Technical Advisory Bulletin (TAB)

Bulletin #: TBMELCO03A

Product: MELCO WIDE ANGLE CAP FRAME DRIVER OPTION

Subject: Wide Angle Cap Driver (Red) Cap Supports

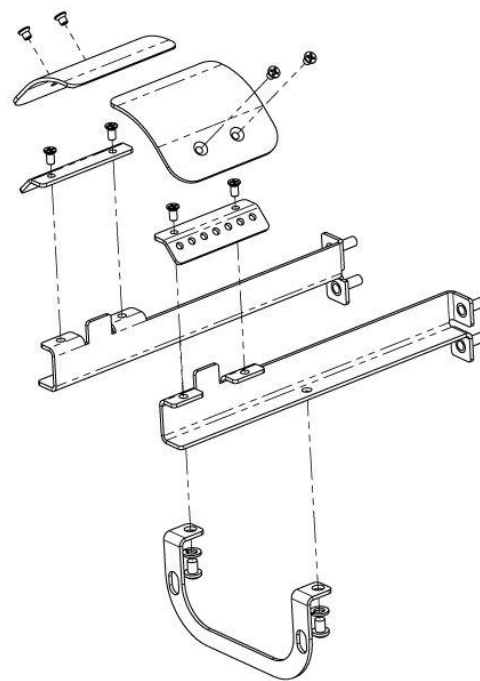
After receiving numerous feedback from customers, trainers, technicians and other Melco staff, it was decided to no longer include the Cap Support Assembly, shown below, on the Wide Angle Cap Driver Assembly. In most cases, the Cap Supports have been removed by customers based on application experience or on recommendation by Melco.

The Cap Support Assembly includes the following part numbers:

- 34173, 34172, 34171, 34170, 34168 and related fasteners.

For those customers who require the Cap Support Assembly for their application, it can still be purchased separately. The Melco part number is 34665.

Existing customers can be instructed to remove the Cap Support Assembly as required to help solve cap sew quality issues. Inform new and existing customers that the Cap Support Assembly is available to order for special applications as identified in the Parts Manual and installation instructions are in the Operators and Technical Manuals.
